ADDENDUM NO. 2

PROJECT: **ADDITION TO THE BLUEBERRY PAVILION
WILMOT ORCHARDS, 3377 CONCESSION RD. 3, CLARINGTON, ONTARIO
PROJECT NO. 19.316**

DATE: June 10, 2020

1D
WINDOW W10
 A201 SCALE: 1/4" = 1'-0"

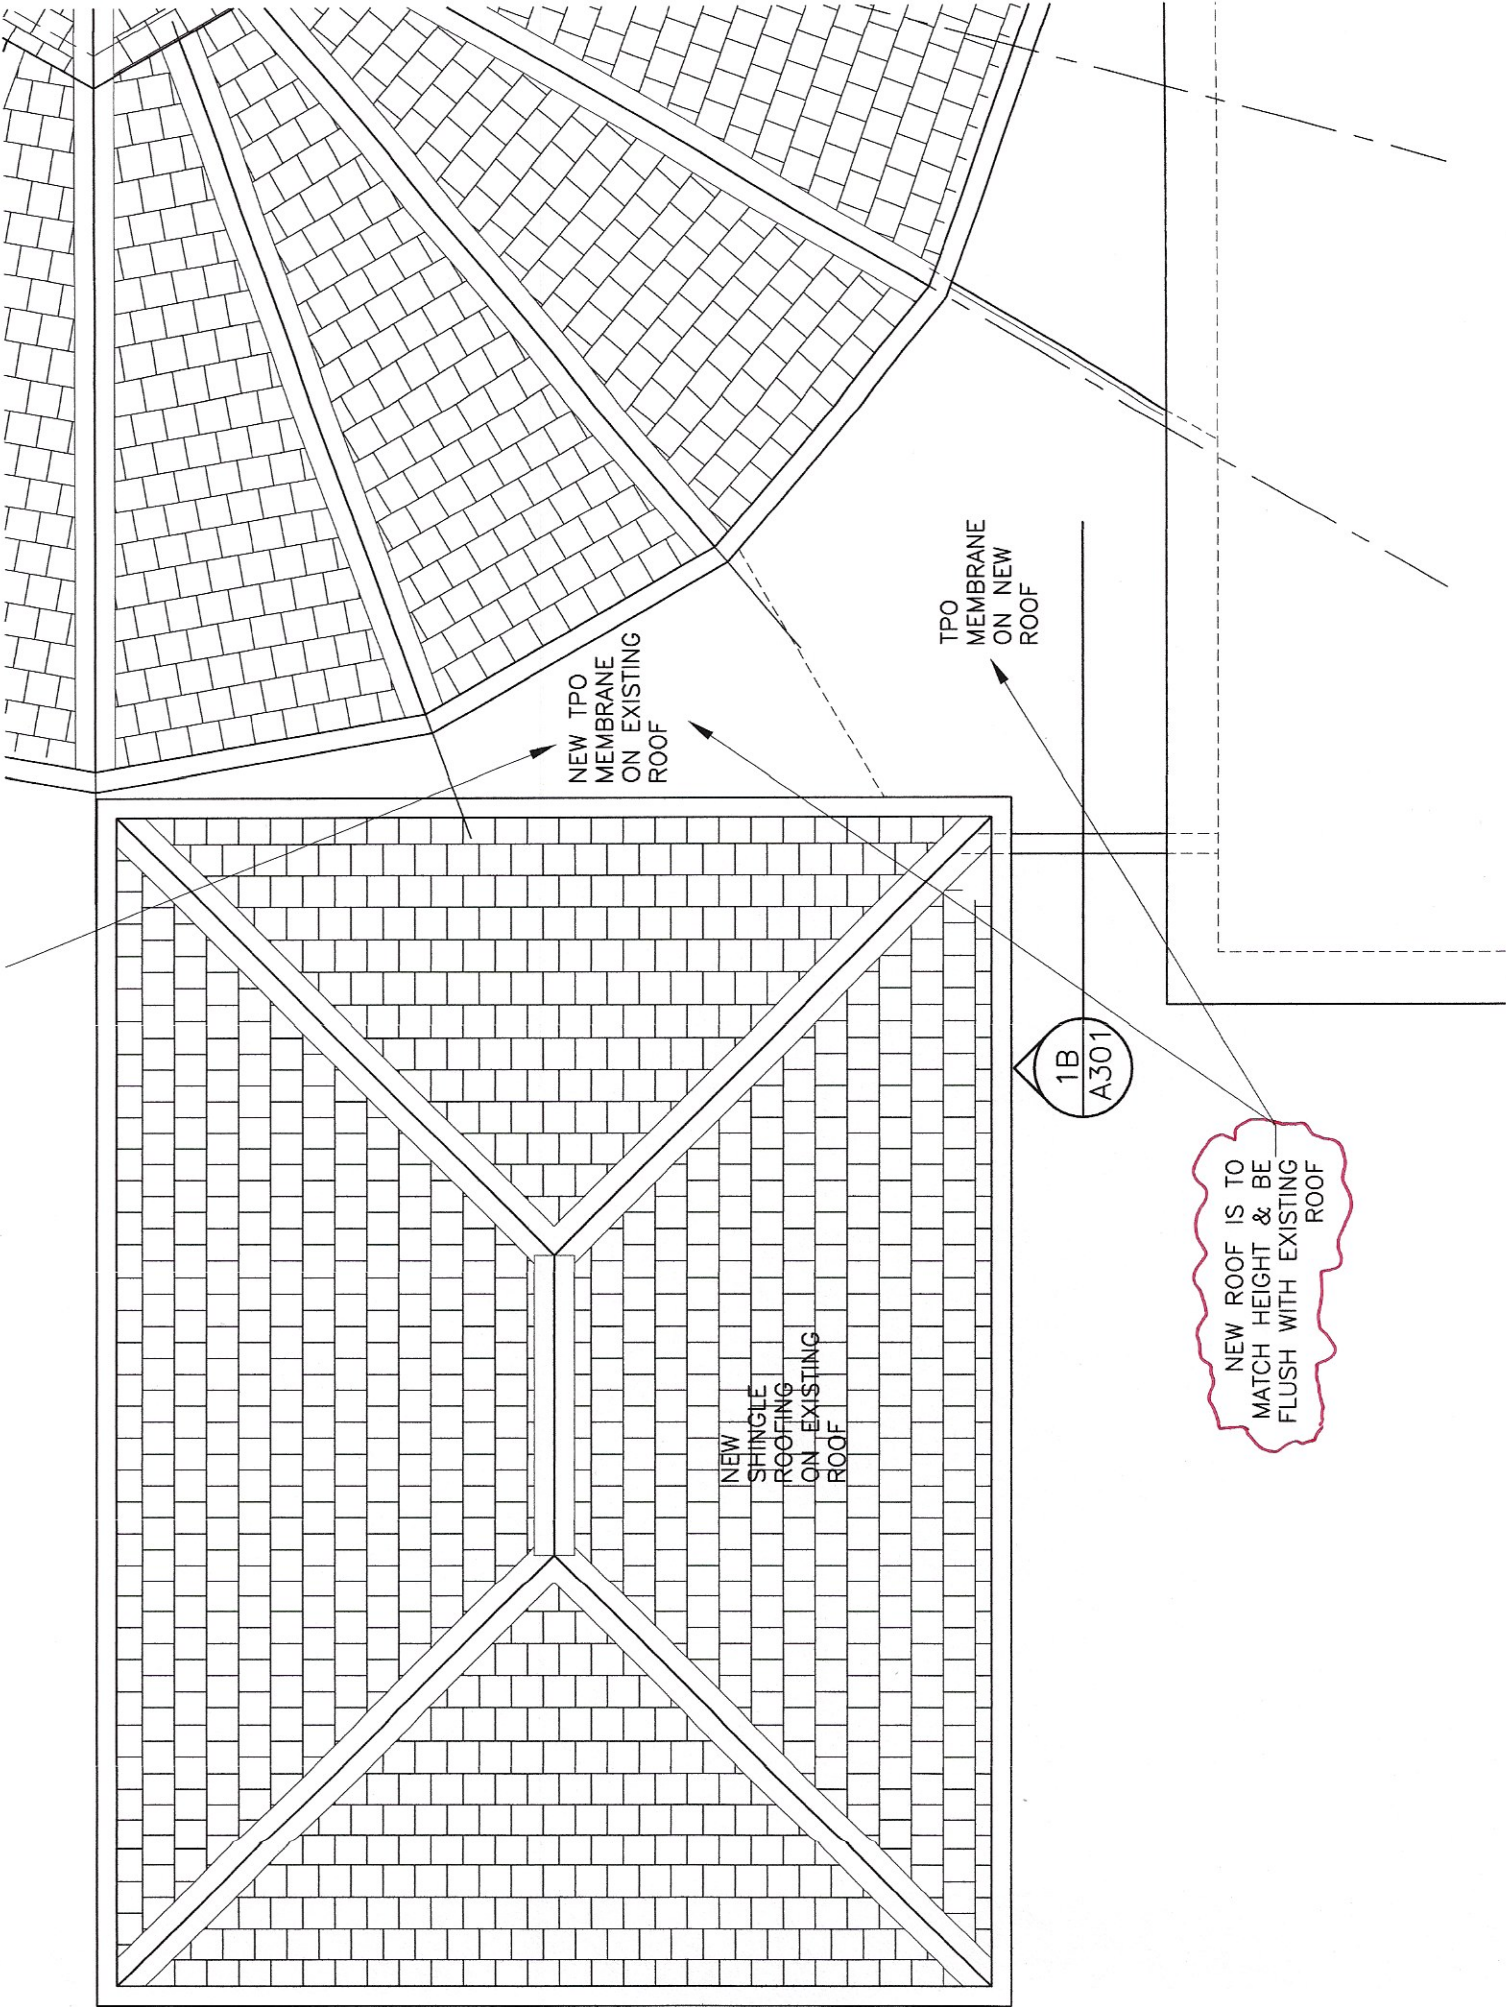
2. Refer to elevation drawing 1D/A201 showing Window W10, appended to this addendum. Provide aluminum closures where window abuts existing stone-clad pier as noted on drawing, and in same finish as window framing.

PARTIAL ROOF FRAMING PLAN

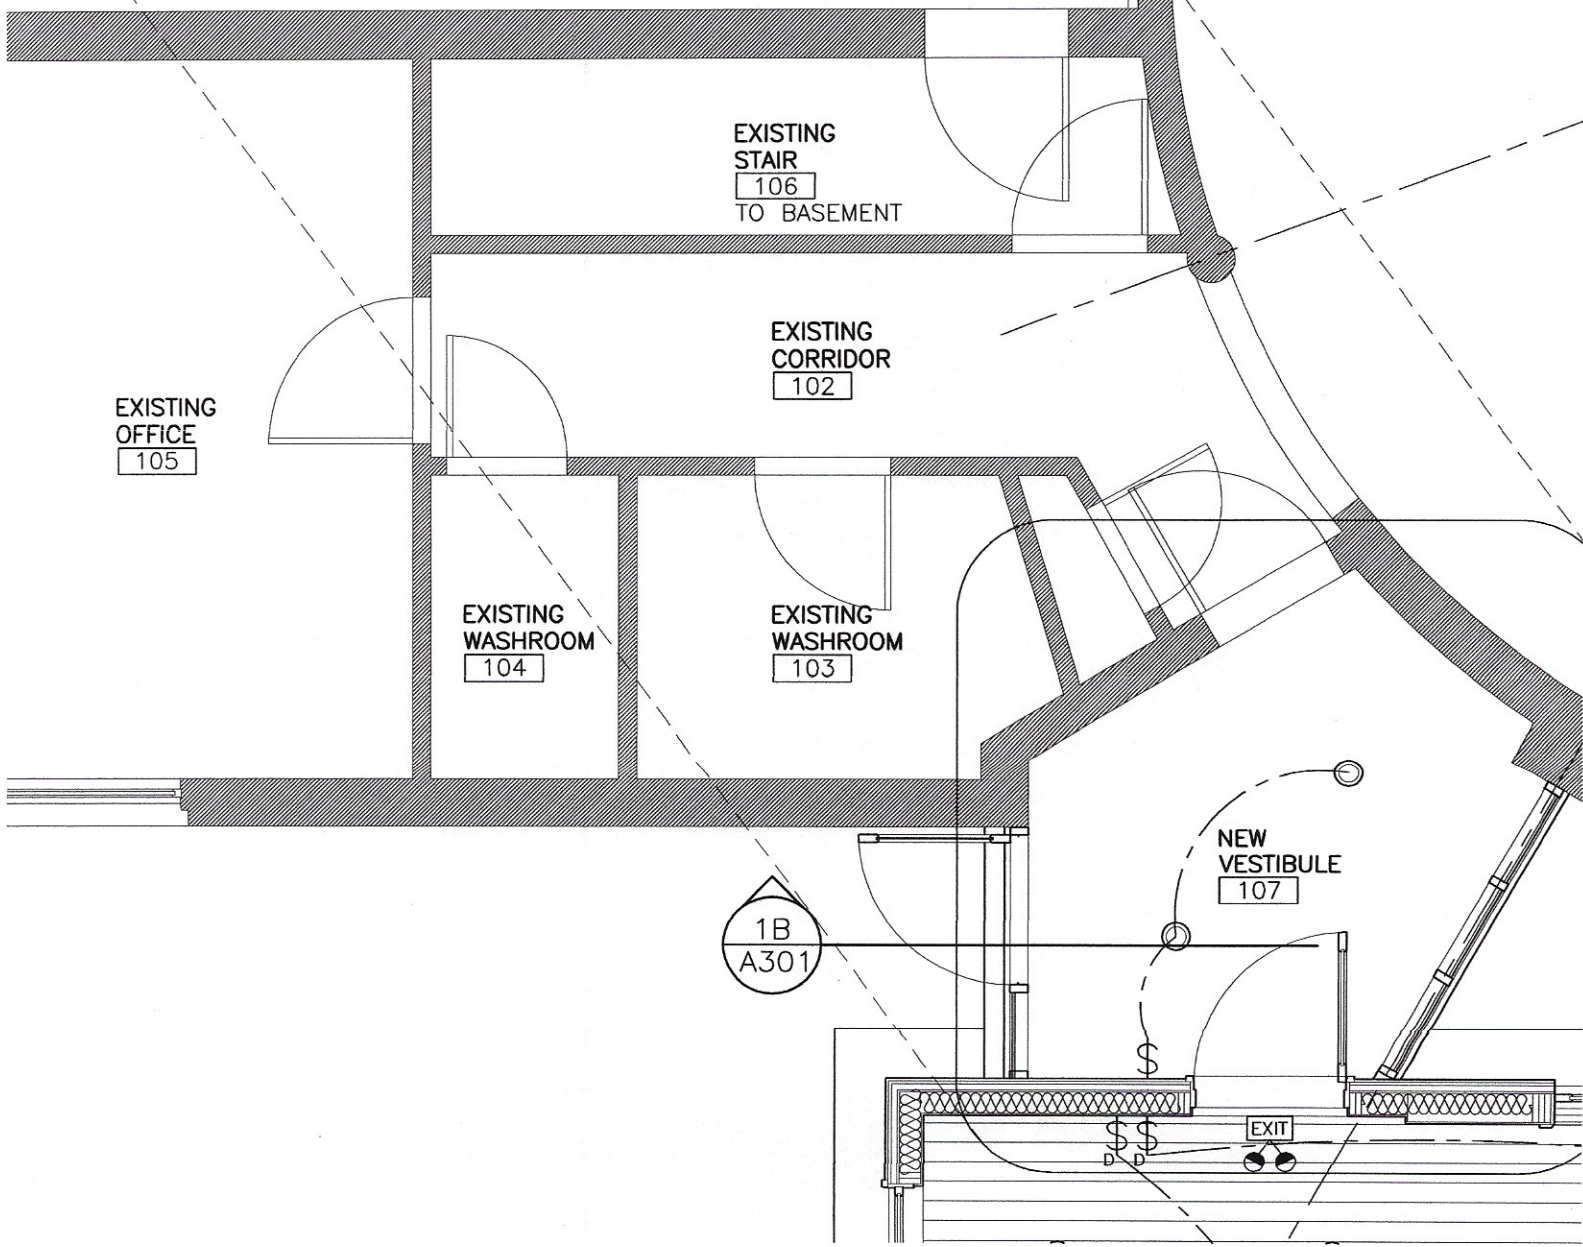
3. Refer to partial roof plan appended to this addendum. Frame new vestibule roof so membrane roofing is flush where it abuts new membrane roofing on existing adjacent roof.

4. Refer to partial reflected ceiling plan drawings appended to this addendum. Partial roof framing plans have been added to clarify intent for framing of new vestibule roofs.

NEW ROOF IS TO
MATCH HEIGHT & BE
FLUSH WITH EXISTING
ROOF

KERF-CUT BACK OF LEDGER TO FOLLOW PROFILE OF EXISTING STONE-CLAD WALL & SECURE WITH 1/2" ANCHOR BOLTS 16"OC

5 ROOFING TERMINATION AT VESTIBULE WALLS

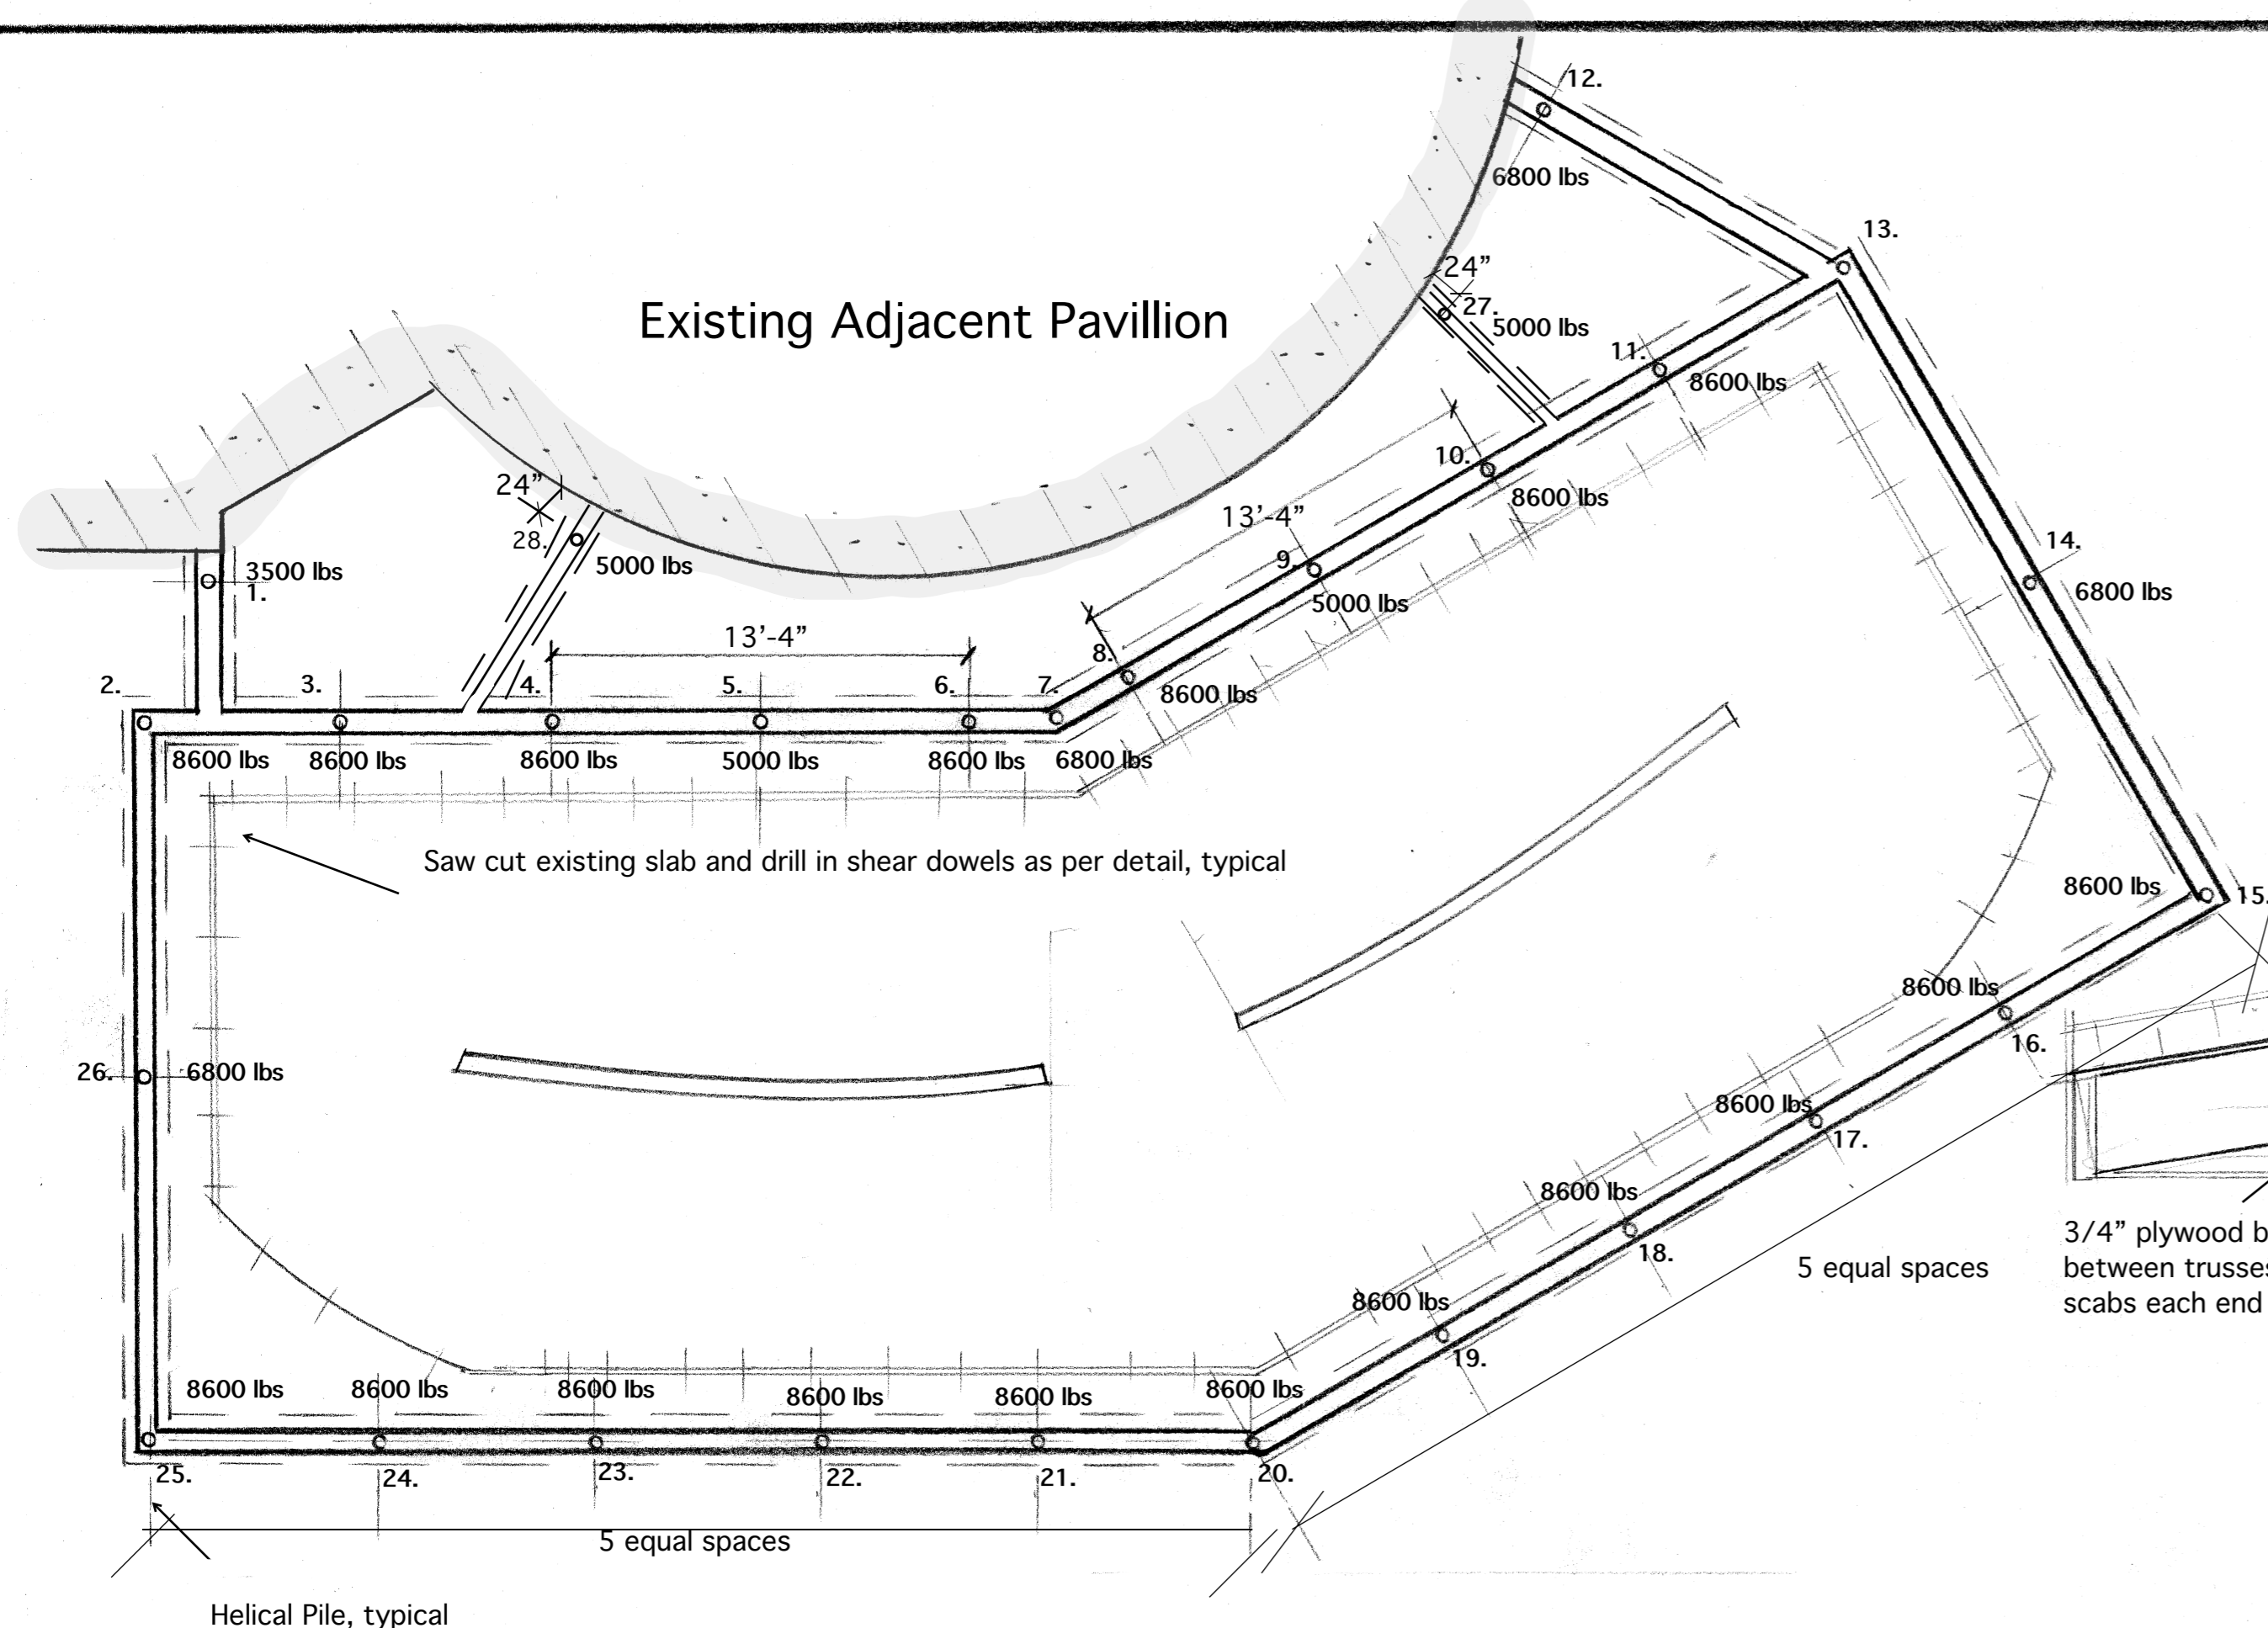
5. Refer to new detail 5/A401 appended to this addendum, showing intent for roofing termination where vestibule roof abuts new and existing walls.
6. Refer to Addendum No. 1, previously issued June 5, 2020. Delete note 2.1. and replace with "Assume a required helical pile installation depth of 14' plus 4' for the footing excavation, for an overall depth of 18' from current grade."
